Report: TAB Report
Function: Test, Adjust, & Balance
Date: 10/23/2025
Completed By: National TAB

PROJECT
10-13-25 QT #0839 MABLETON, GA

Project: 10-13-25 QT #0839 MABLETON, GA

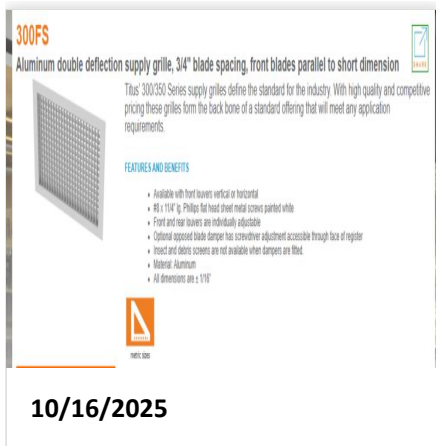
- DIFFUSERS ARE THE WRONG TYPE
- EF-1: MISSING EXHAUST GRILLE
- HOOD SIDE PANELS

Asset: EF1

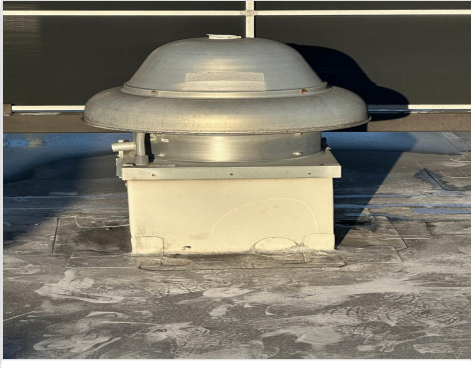
[1] INCORRECT COMBI-OVEN GRILLE INSTALLED. UNABLE TO BALANCE FAN WITH INSTALLED GRILLE. SEE ISSUE.
